STAFF RECOMMENDATION
311 West End Place
July 20, 2016

Application: New construction – outbuilding; Setback determination
District: Richland-West End Neighborhood Conservation Zoning Overlay
Council District: 24
Map and Parcel Number: 10405036100
Applicant: Van Pond, Jr.
Project Lead: Melissa Sajid, Melissa.sajid@nashville.gov

East Elevation (Facing House)

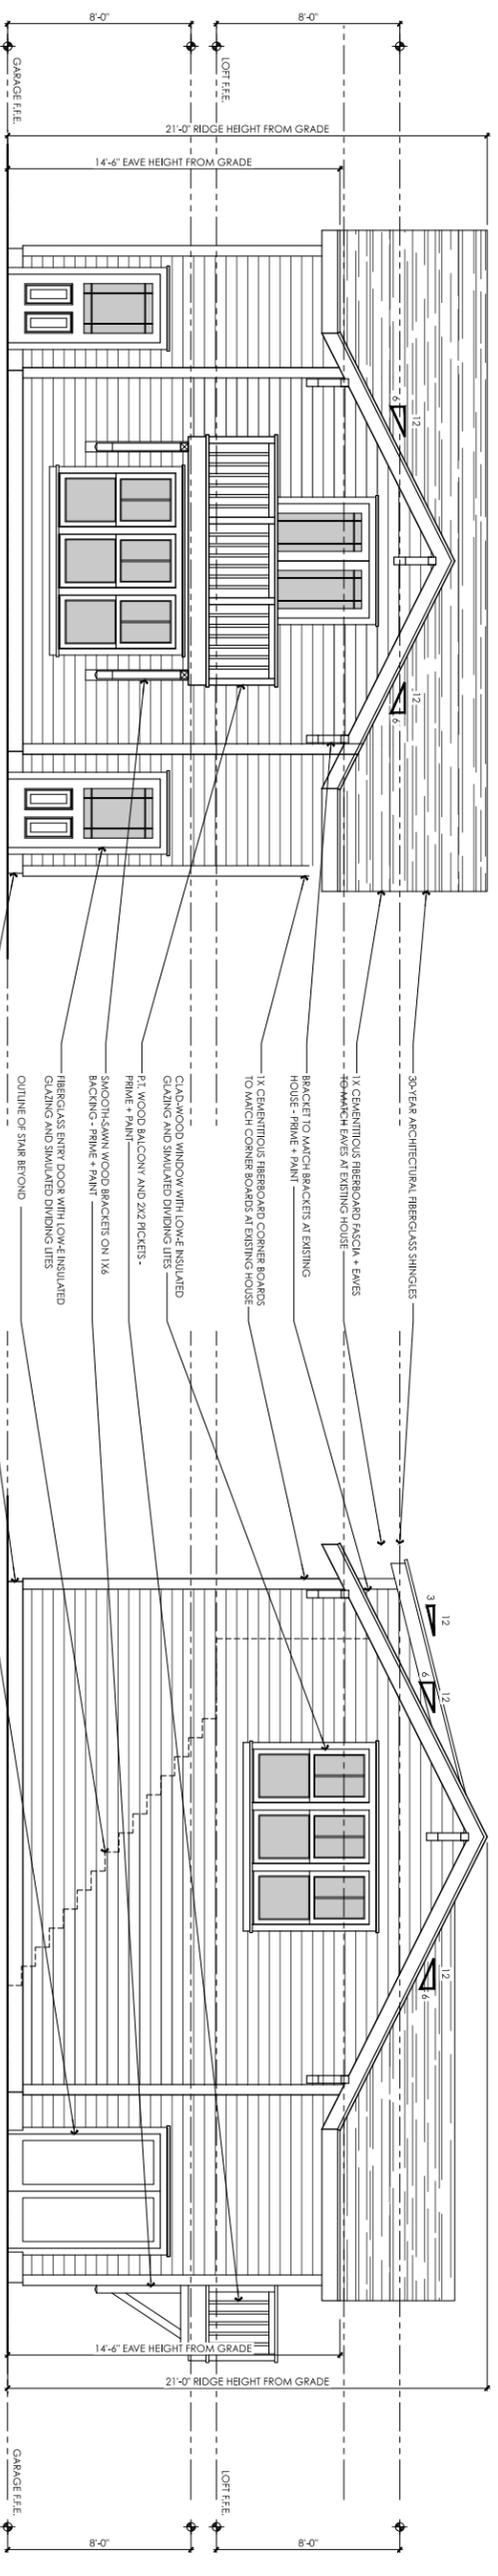
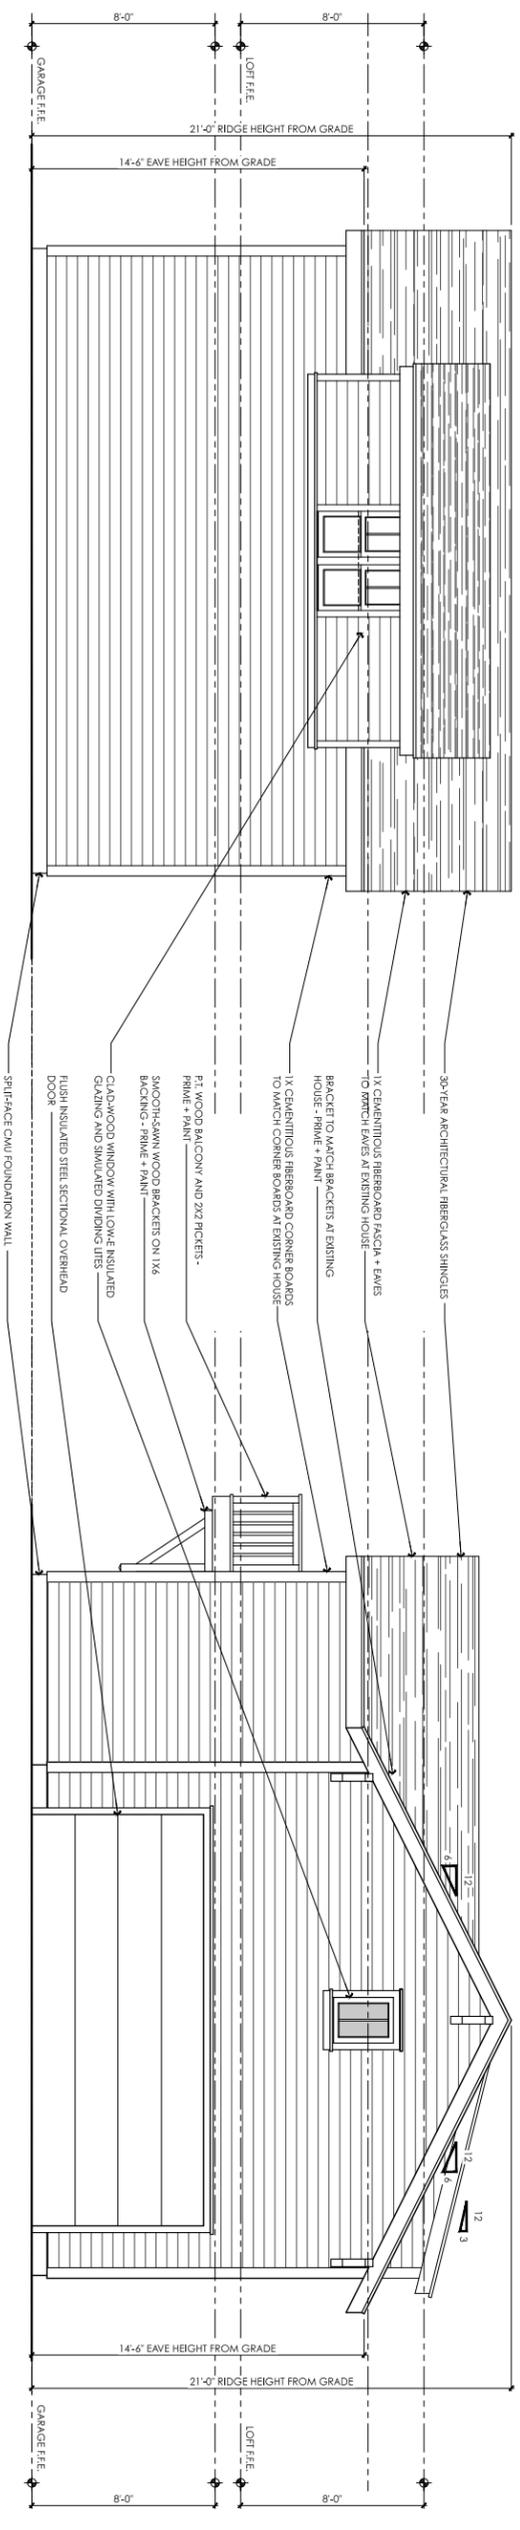
The proposed detached garage is two stories and does not exceed the maximum footprint or ridge height per the design guidelines. However, the outbuilding is a two-story accessory for a one and one-half story house and does exceed the

maximum average eave height of the house by one foot, three inches (1'-3"). As an accessory structure, the outbuilding should be subordinate to the house not only with regard to footprint and overall height but also with respect to eave height. Staff recommends a condition that the average eave heights of the outbuilding not exceed the average eave height of the historic house. With this condition, staff finds that the project meets Section II.B.1.h.1 of the design guidelines.

The outbuilding includes a wall dormer on the rear façade. The design guidelines require that dormers set in at least two feet (2') from the wall below, and this requirement is also included in the Zoning Code requirements for detached accessory dwelling units. However, the proposed outbuilding is not a DADU, so staff finds that the proposed wall dormer could be appropriate in this case as it faces the alley and the use is not subject to the DADU requirements. The project meets section II.B.h.1 of the design guidelines.

1. Staff approve the final details, dimensions and materials of windows, doors, garage door, roof color, and driveway material prior to purchase and installation; and
2. The average eave height of the outbuilding shall not exceed the average eave height of the historic house.
